Access Compliance Report

Public Rights-of-Way

(Curb Ramps)

Intersection ID: 31707	Main Street: ATLAS_CEDAR_DR	Cross Street: WEEPING_FIG_LN	Location: SE
ADA ID: B47FC7690549	Ramp Type: PerpDiag	Initial Pass/Fail: Fail	Overall Compliance: No
Severity Score: 22.5			
Codes/Mitigation Info/Possible Solution		Field Measurements/Component Compliance

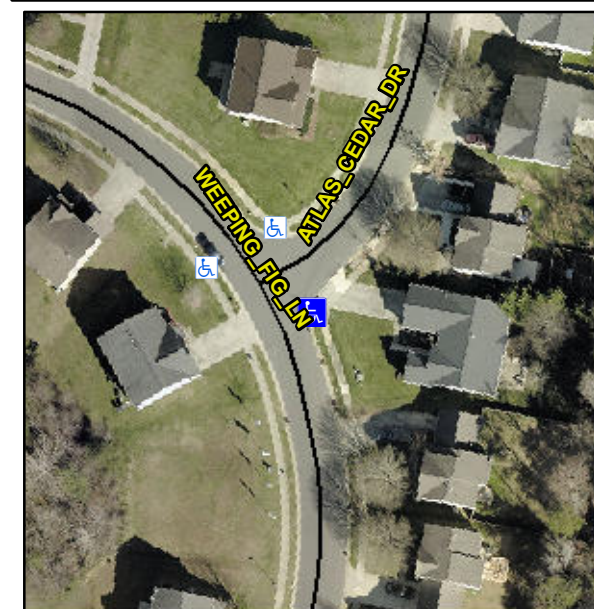
Not Found, R304.5.1, R304.2.2, R304.5.3

Compliance	Description	Data	Compliance	Description	Data
N/A	Ramp Length (in)	45.5	No	Ramp Slope (%)	11.1
No	Ramp Width (in)	41.0	No	Ramp XSlope (%)	3.8
N/A	Flare Type LT	N/A	N/A	Flare Type RT	N/A
N/A	Flare Slope LT (%)	N/A	N/A	Flare Slope RT (%)	N/A
N/A	Flare Traversable LT?	N/A	N/A	Flare Traversable RT?	N/A
N/A	Landing Length (in)	N/A	N/A	DWS Provided?	N/A
N/A	Landing Width (in)	N/A	N/A	DWS Contrast?	N/A
N/A	Landing Slope (%)	N/A	N/A	DWS Length (in)	N/A
N/A	Landing X Slope (%)	N/A	N/A	DWS Full Width?	N/A
N/A	Landing Curb? (Y/N)	N/A	N/A	DWS Offset (in)	N/A
N/A	Shared Landing?	N/A			
N/A	Gutter Ponding?	N/A	N/A	Gutter Slope (%)	N/A
N/A	Gutter Lip Ht (in)	N/A	N/A	Gutter X Slope (%)	N/A
N/A	Painted X Walk1?	No	N/A	Painted X Walk2?	No
	X Walk 1 Direction	To N		X Walk 2 Direction	To W
N/A	X Walk 1 Width (in)	N/A	N/A	X Walk 2 Width (in)	N/A
	X Walk 1 Slope (%)	3.0		X Walk 2 Slope (%)	2.1
	X Walk 1 X Slope (%)	1.2		X Walk 2 X Slope (%)	3.4

Remove & Replace Curb Ramp With Two New Directional Ramps or Equivalent.
